PLANNING COMMISSION MEETING

LOCATION: TOWNSHIP ANNEX, 7527 HIGHLAND ROAD, WHITE LAKE, MI 48383
THURSDAY, JULY 20, 2023 – 7:00 PM

RE: Sunset Cove Condominiums- Preliminary Site Plan Review – 3rd Review

RE: Sunset Cove
Preliminary Site Plan and Special Land Use – Review #3

DRAWING:
C-10

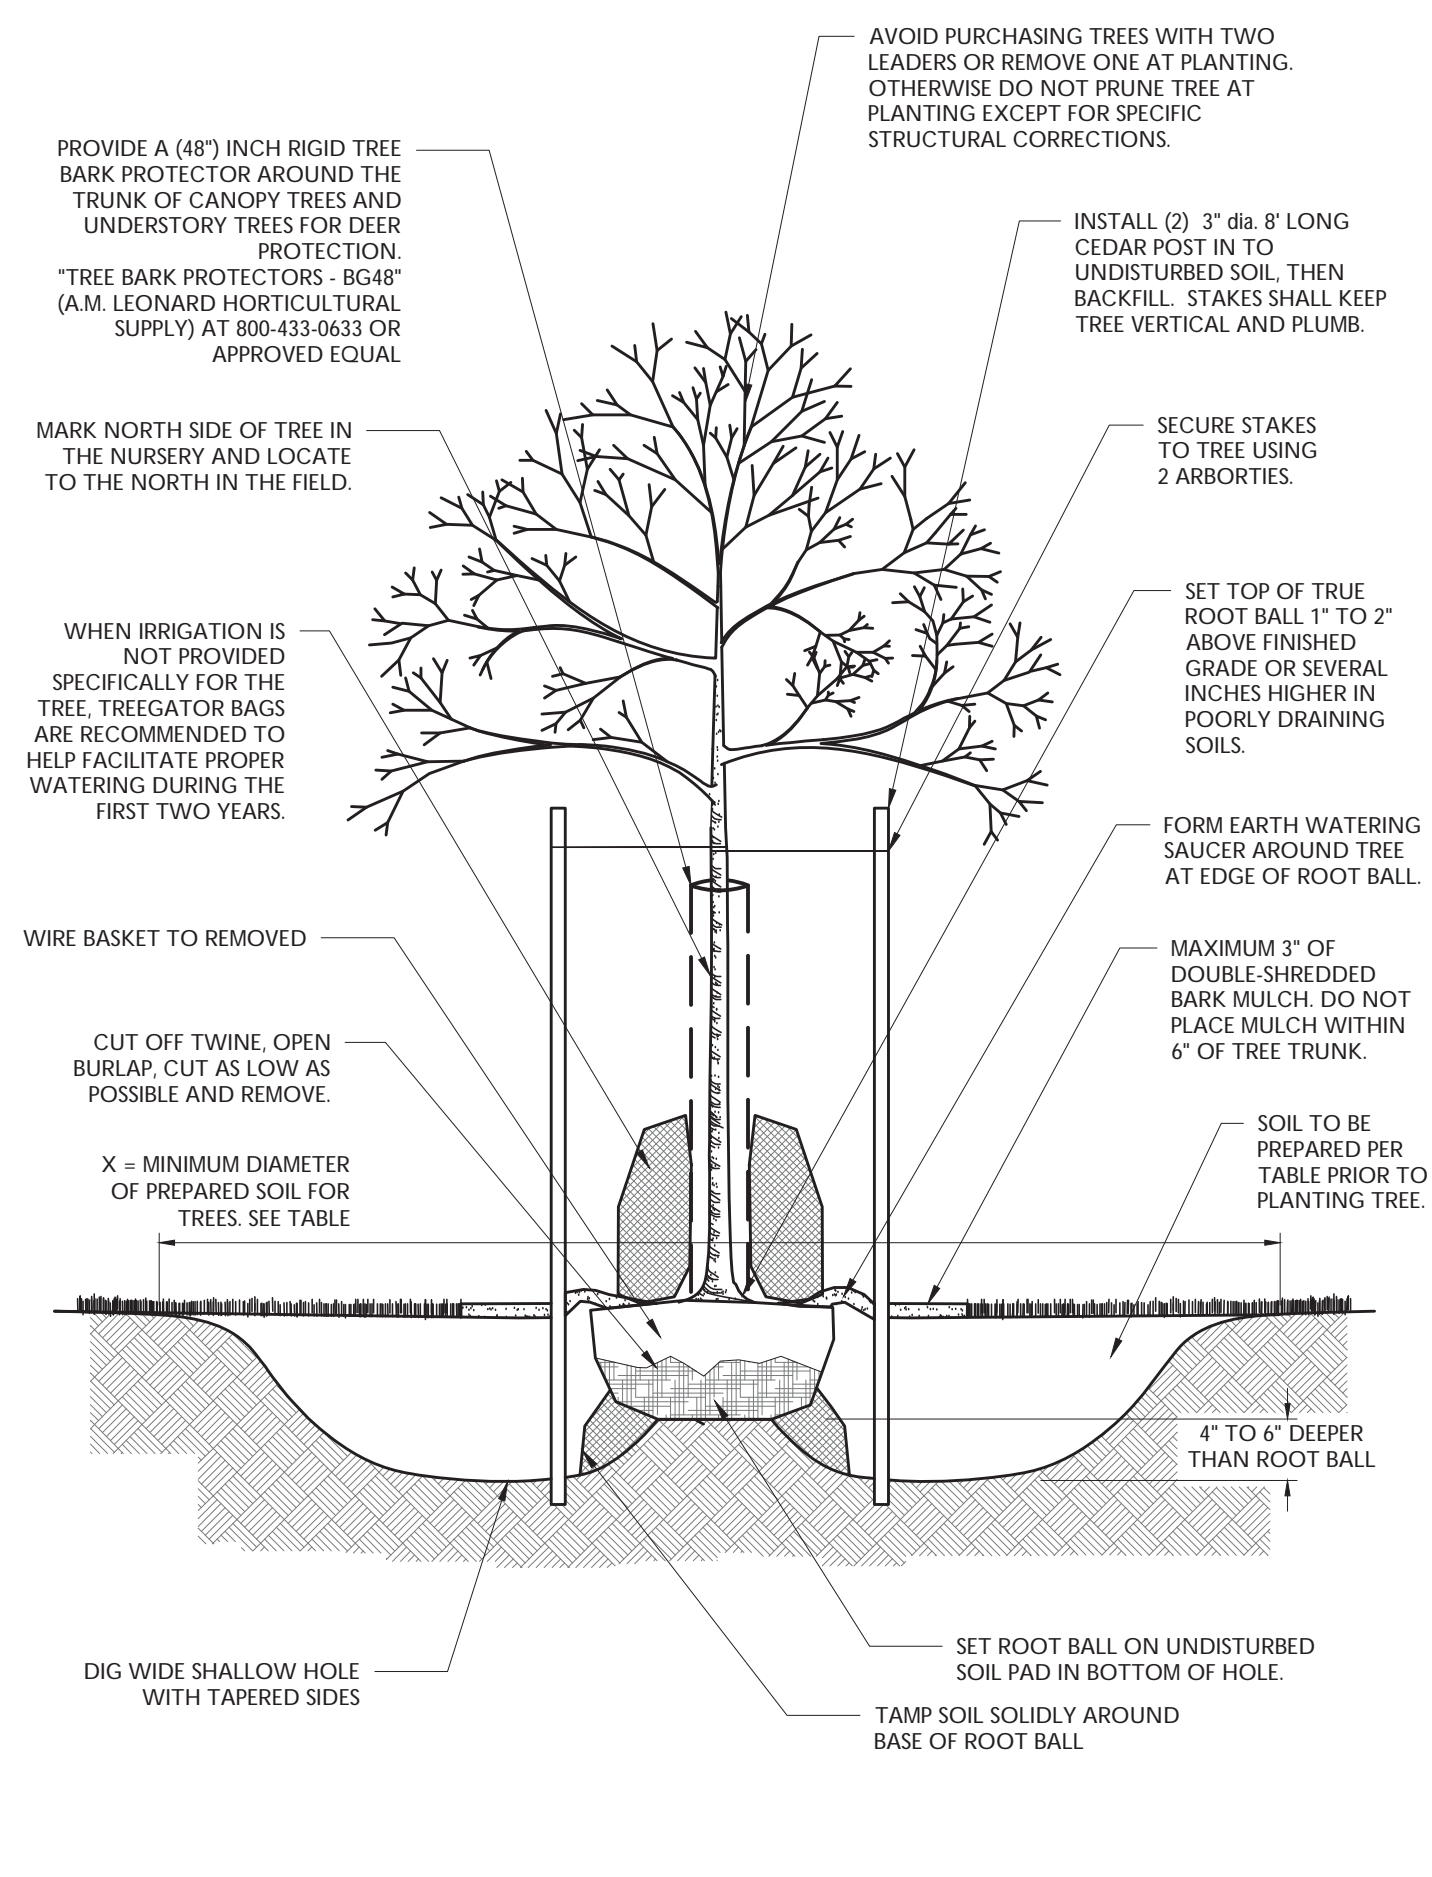
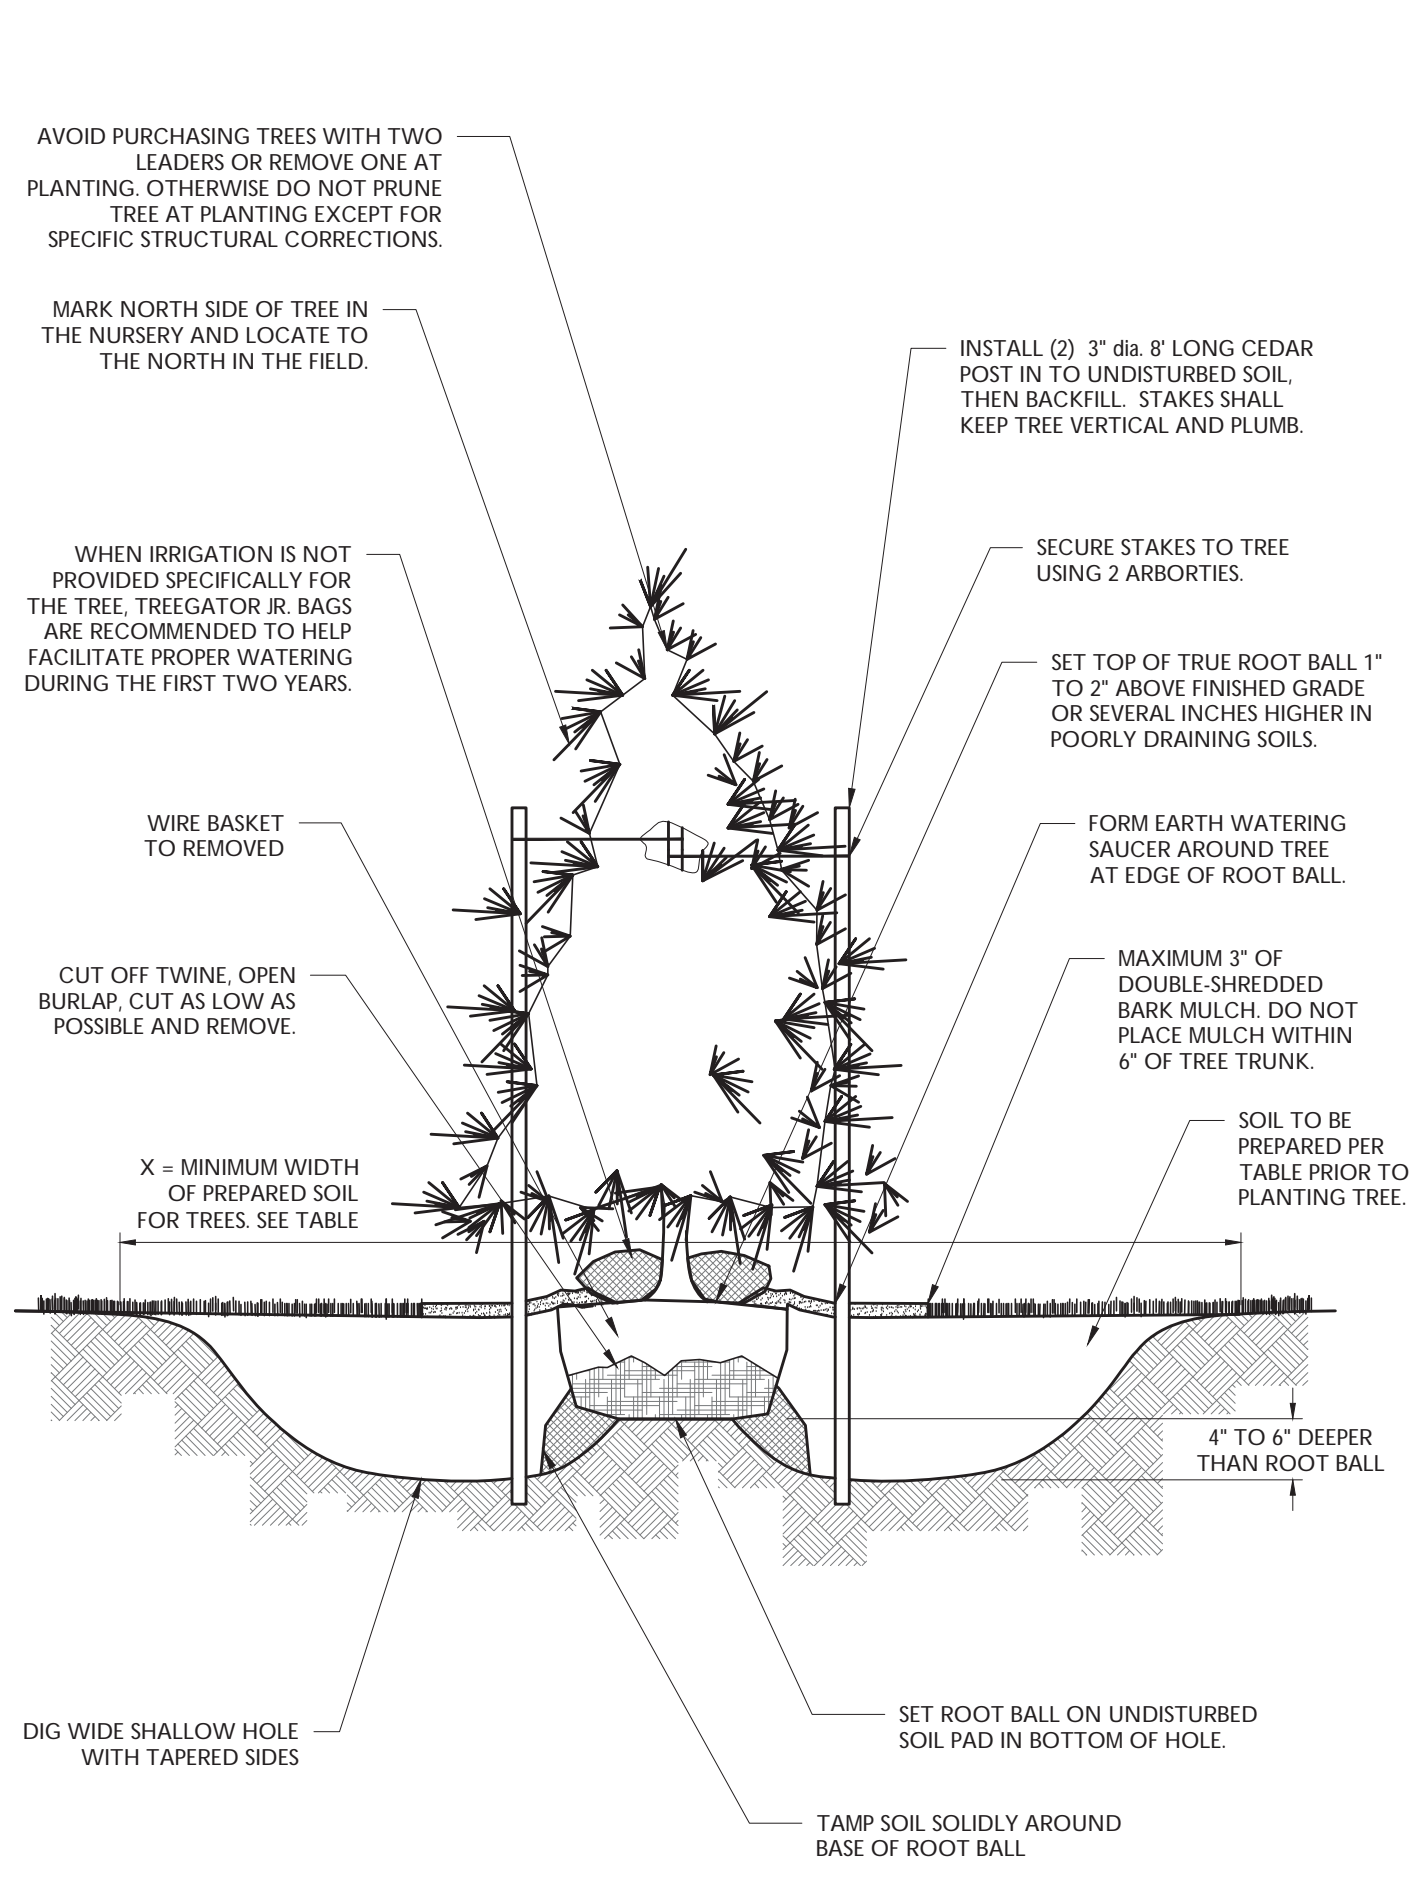
- **The tree and shrub planting details on Sheet C-10 mention mulch. The zoning ordinance states the mulch product itself shall be at least doubled-shredded quality. Revise accordingly.** (Comment addressed. Details have been updated to note double-shredded mulch).

DRAWING:
C-14

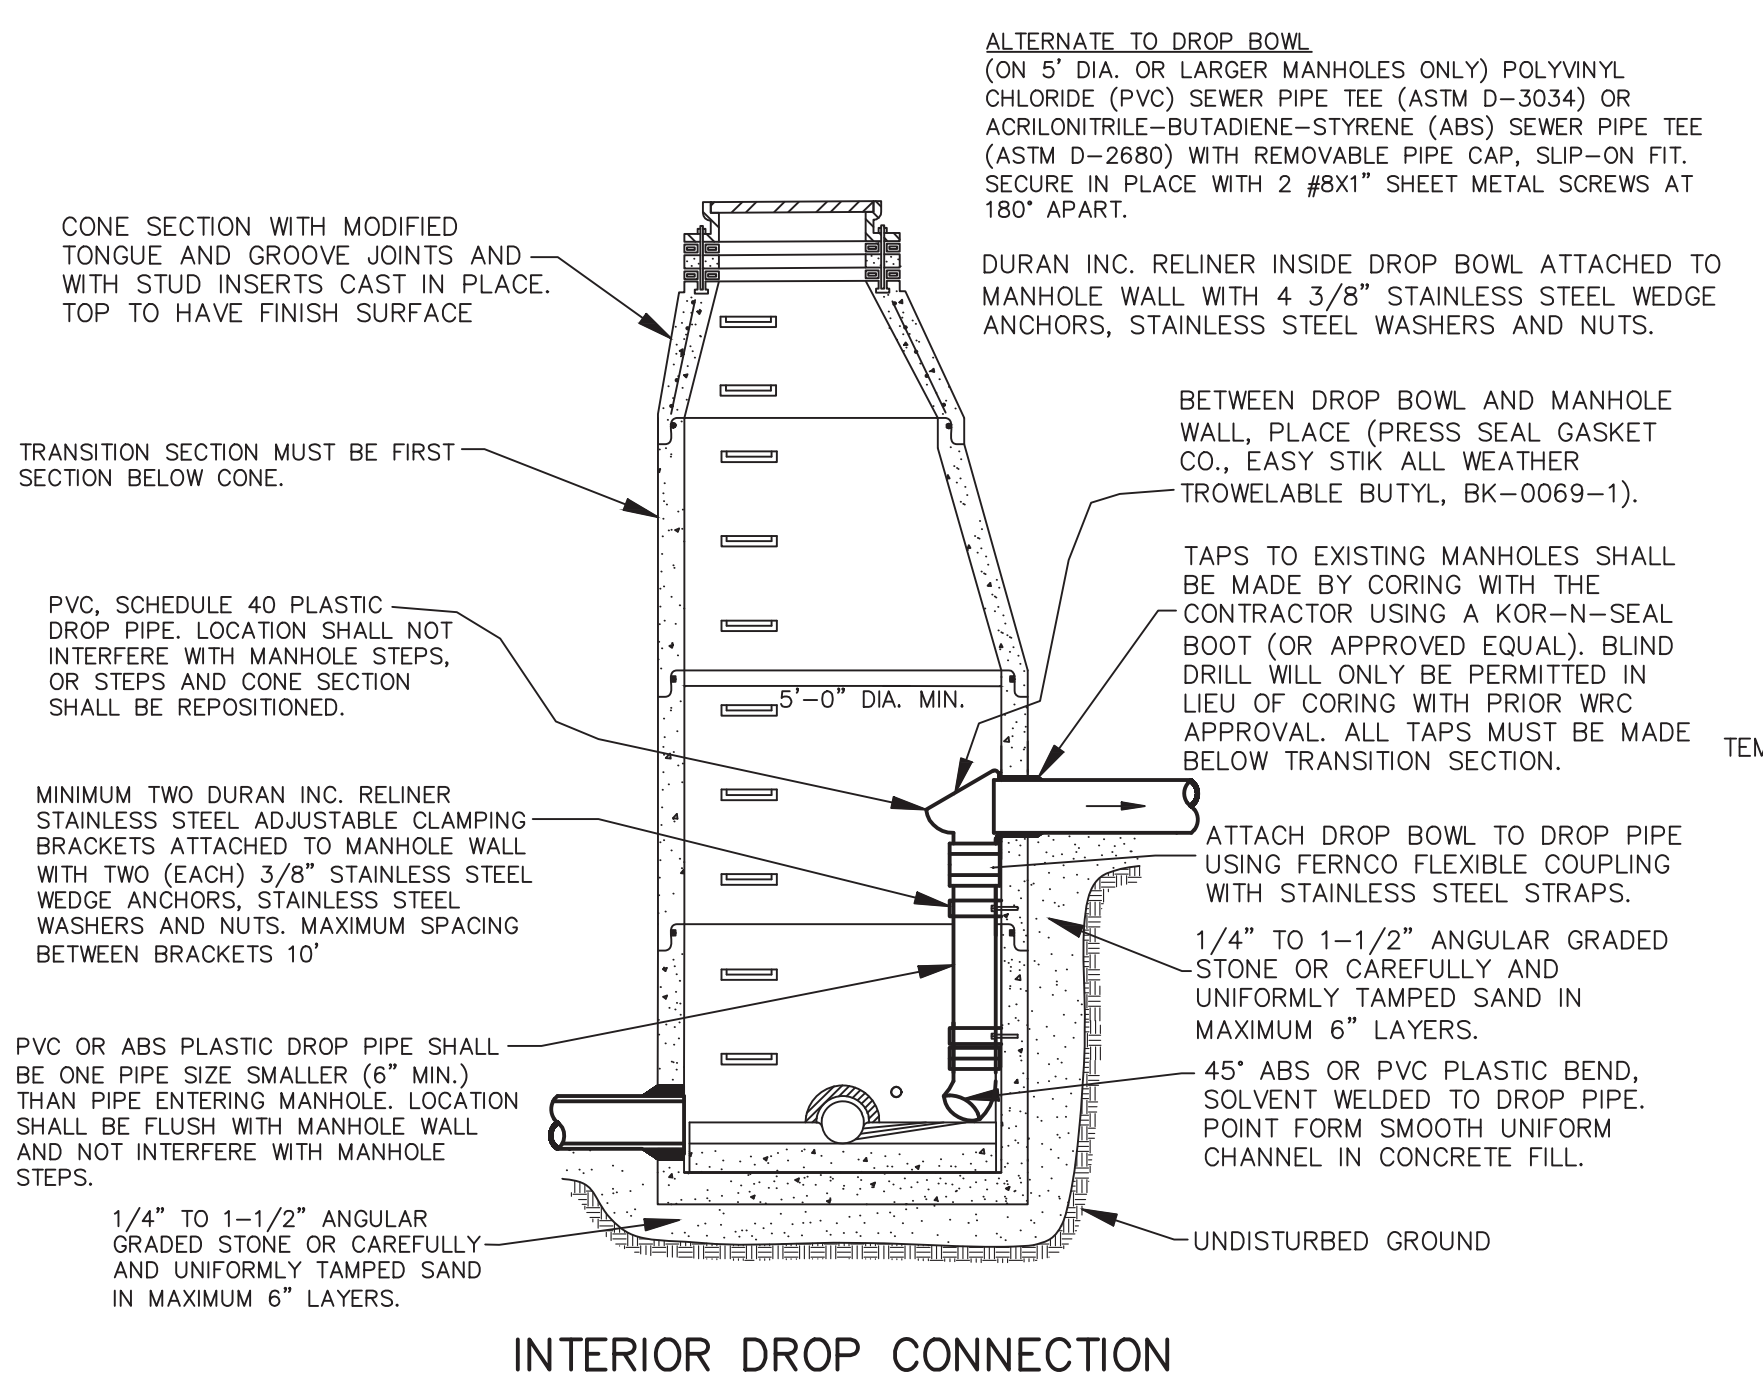
The Fire Truck Turning Exhibit (Sheet C-13) indicates a fire truck traversing over a curb, landscaping, a snow storage area, a sidewalk, and another curb to exit the site. Driving outside of designated fire lanes is not, pursuant to the zoning ordinance, acceptable for the efficient and effective use of fire apparatus (likely also noncompliant with the Fire Code). Sheet C-13 shall be revised to demonstrate fire apparatus can enter and exit the site by utilizing drive aisles/maneuvering lanes and the site driveway. (Comment addressed. The exhibit (now Sheet C-14) has been updated).
